COMMUNITY DEVELOPMENT DEPARTMENT REPORT

HEARING DATE: 7/8/2025

SUBJECT: H-2024-0069
Springday Subdivision – AZ, PP

LOCATION: North side of W. Ustick Rd., 1/4 mile west of N. Black Cat Rd., in the SE 1/4 of Section 33, T.4N., R.1W. (Parcel #S0433438957 & #S0433438850)

F. Common Driveway Exhibit (Lot 34C, Block 10) - REVISED

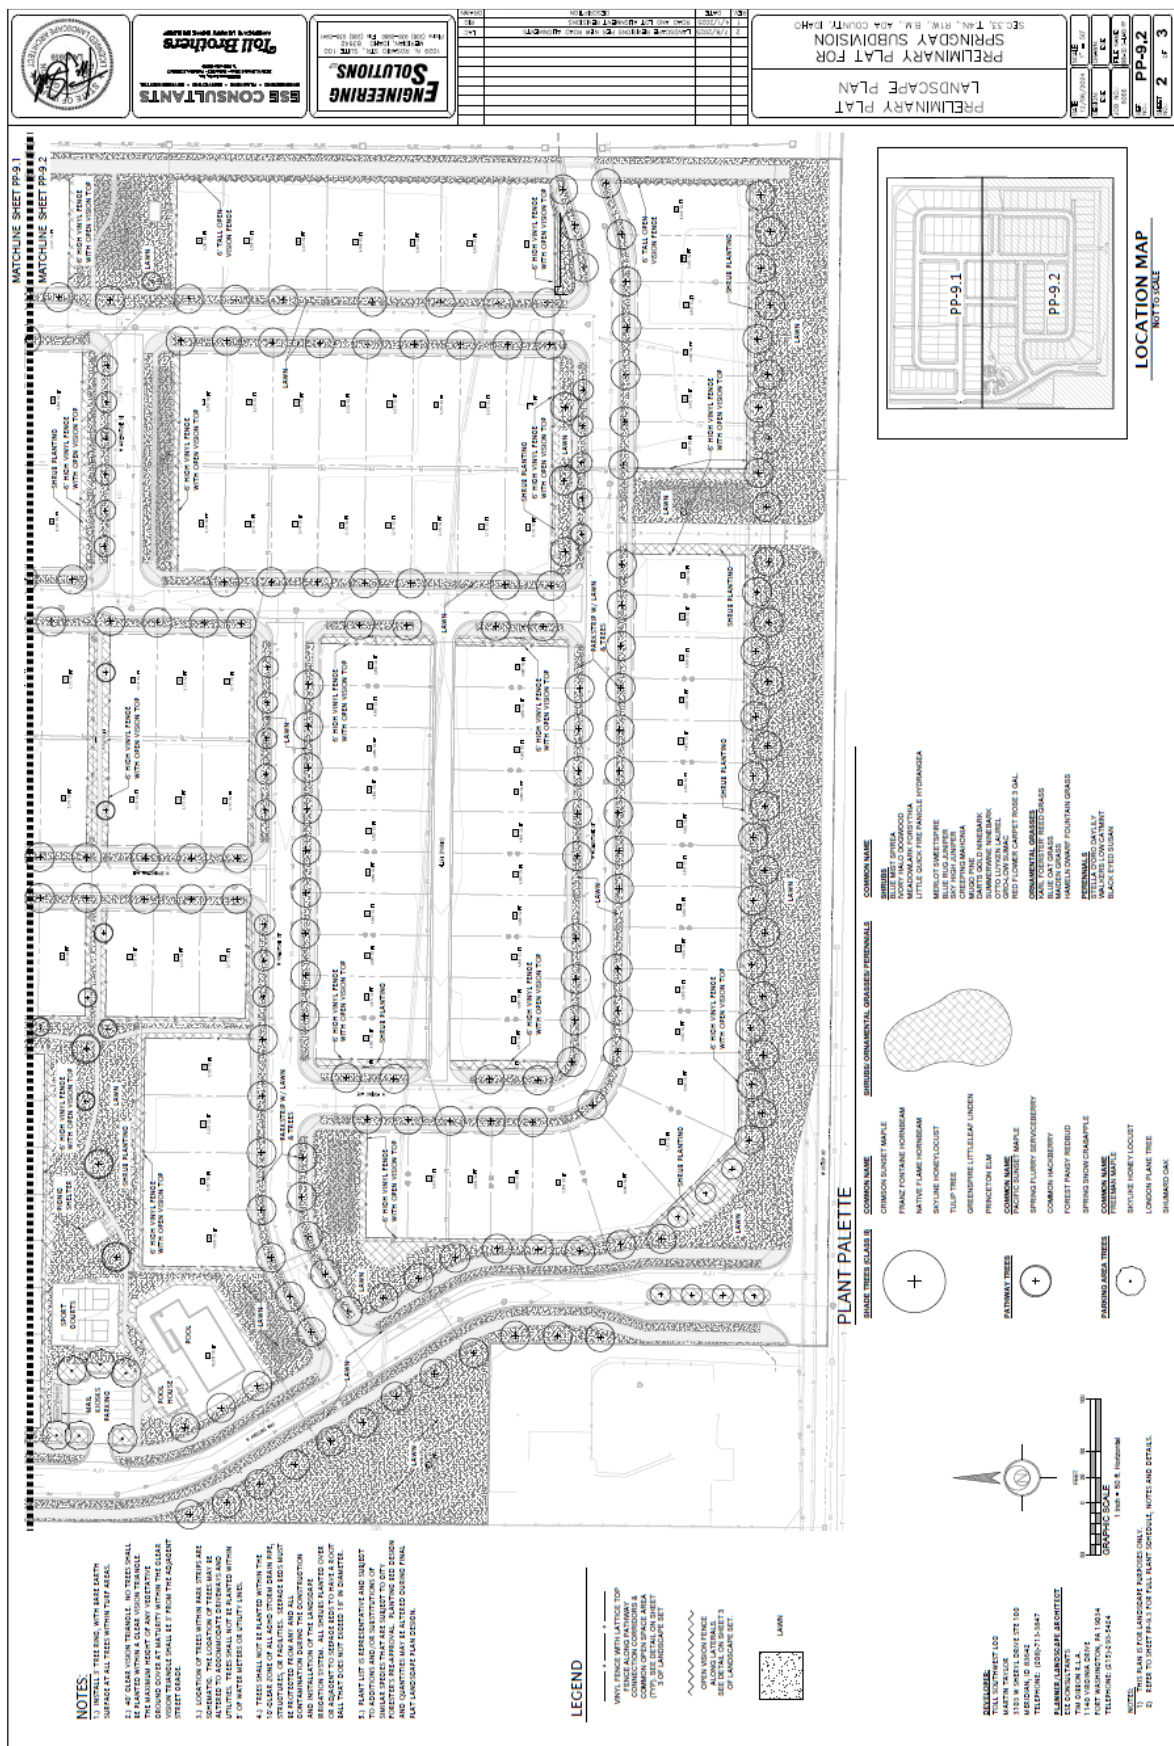
Two (2) common driveways are proposed; see exhibit in Section VII.F below. **All common driveways are required to comply with the standards in UDC 11-6C-3D, which require driveways to be a minimum 20' in width and no more than three (3) dwelling units may be located on one (1) side of the driveway. The plat depicts four (4) dwelling units on one side of each of the driveways and the paved surface of the driveways is below 20 feet. If solid fencing is proposed adjacent to common driveways, a minimum 5-foot wide landscape buffer planted with shrubs, lawn or other vegetative groundcover should be provided between the driveway and fence. The common driveway exhibits, preliminary plat and landscape plan should be revised to comply with these standards with submittal of the final plat application.**

2. The final plat shall include the following revisions:
 - i. Make revisions to the plat to comply with the common driveway standards listed in UDC 11-6C-3D.
 - ii. Depict a temporary turnaround at the north end of N. Avellino Way as required by ACHD.
 - iii. Depict a minimum 35-foot-wide street buffer along the entire frontage of the property along Ustick Rd. in accord with UDC Table 11-2A-6 for entryway corridors, measured from the ultimate sidewalk location as anticipated by ACHD after right-of-way is dedicated for the expansion of Ustick Rd. Depict the ultimate sidewalk location on the plan as anticipated by ACHD.

6. Submit a revised common driveway exhibit that demonstrates compliance with the standards listed in UDC 11-6C-3D.

H. Qualified Open Space Exhibit (date: 3/6/2025)

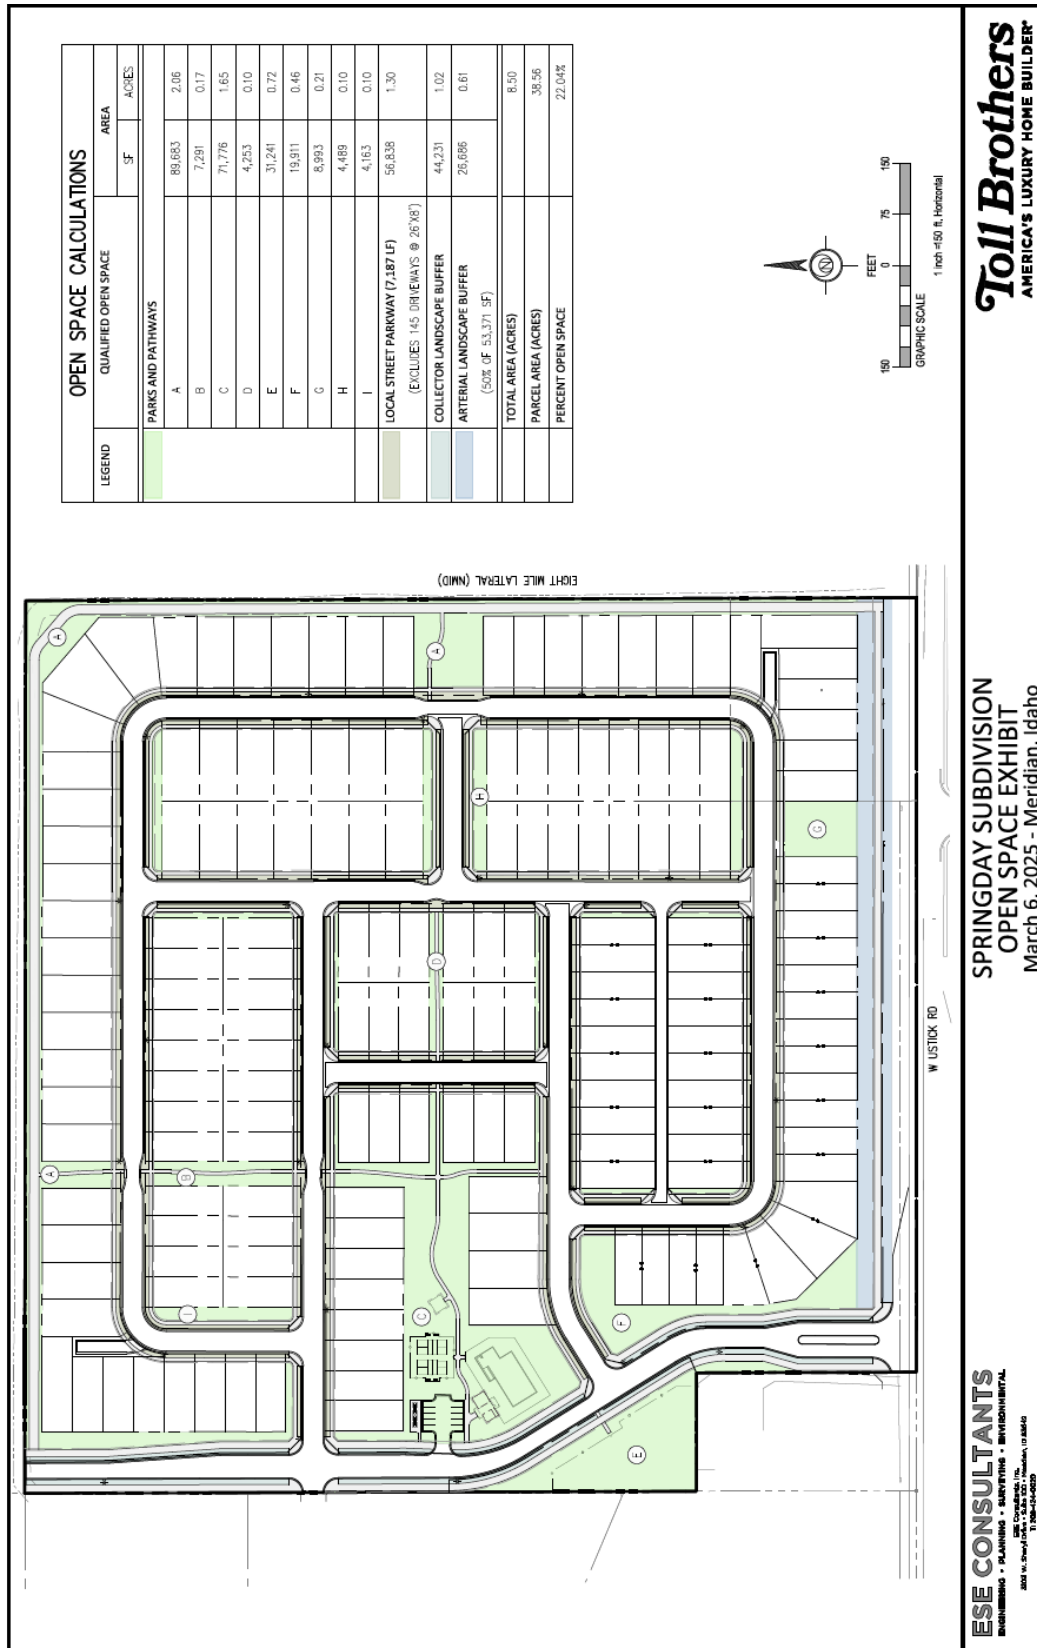
A minimum of 15% qualified open space is required to be provided with development. Based on 38.56 acres, a minimum of 5.78 acres is required; 8.50 acres (or 22.04%) is proposed that meets the quality standards in UDC 11-3G-3A.2 (see exhibit in Section VII.H below).

I. Amenity Exhibit (dated: 11/26/2024)

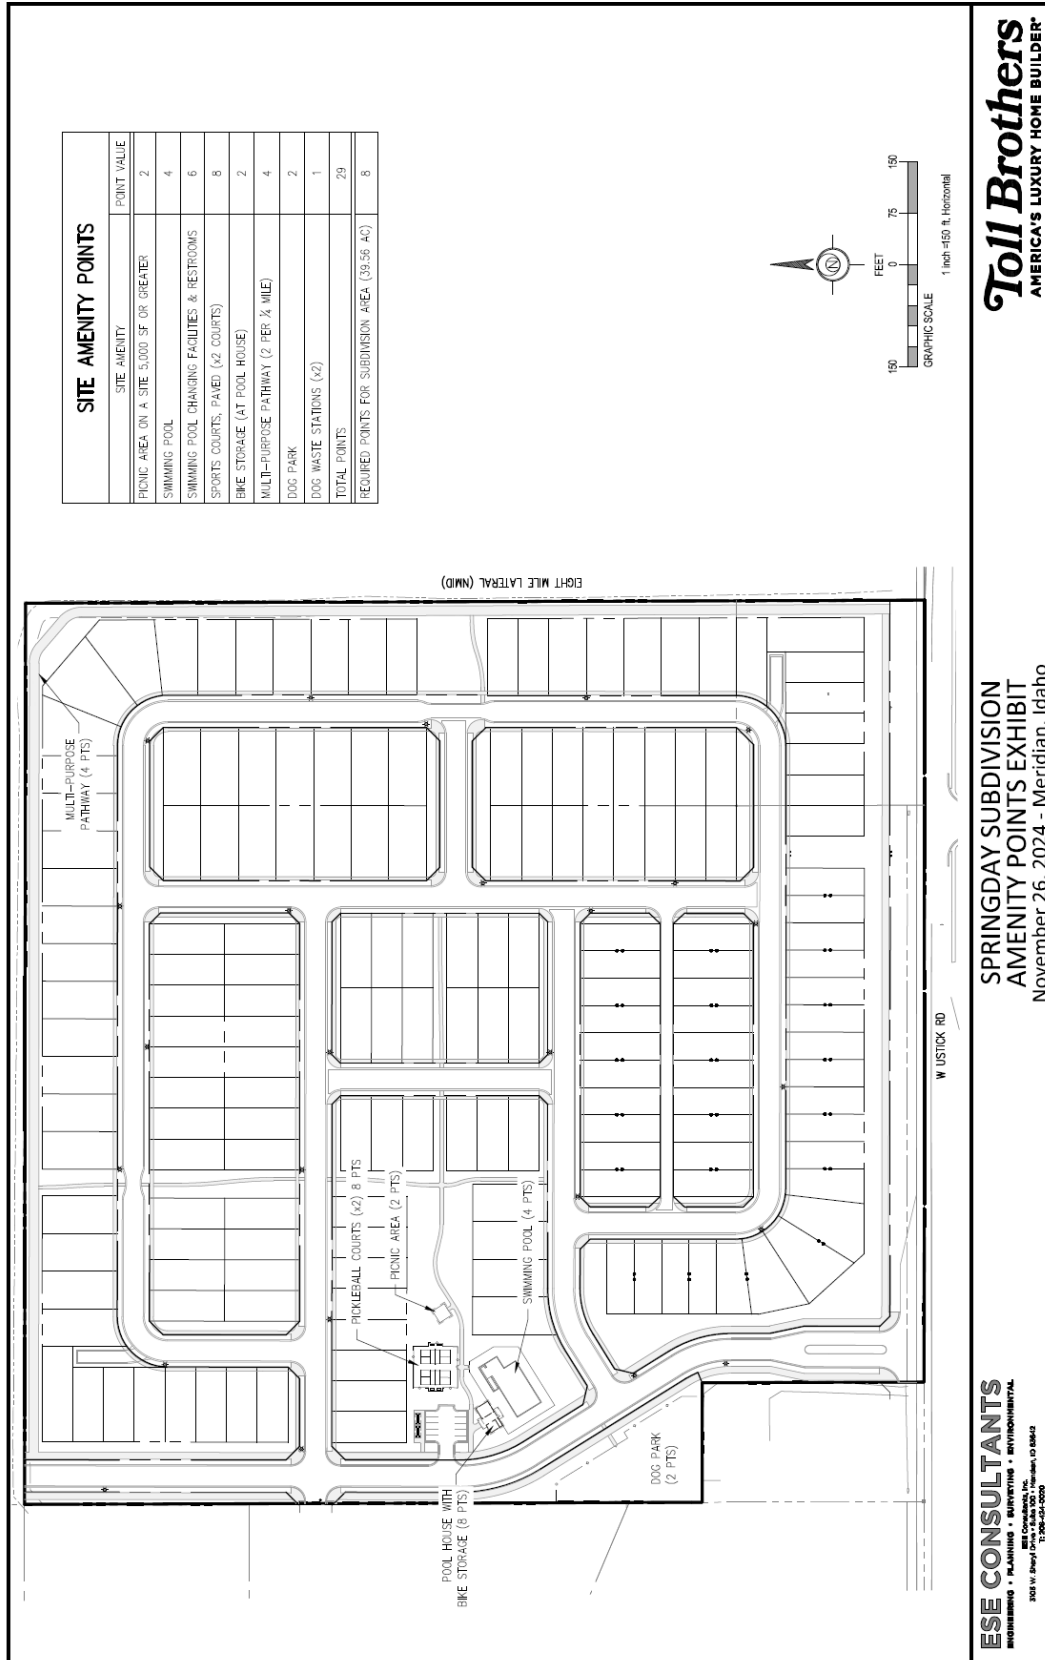
Proposed open space consists of an open grassy area exceeding 5,000 square feet in area, linear open space with pathways, and 50% of the street buffer along Ustick Rd., an arterial street (see exhibit in Section VII.I below).

Based on 38.56 acres, a minimum of eight (8) qualified site amenity points are required to be provided per the standards in UDC 11-3G-4. The Applicant proposes a total of 29 amenity points from the following categories:
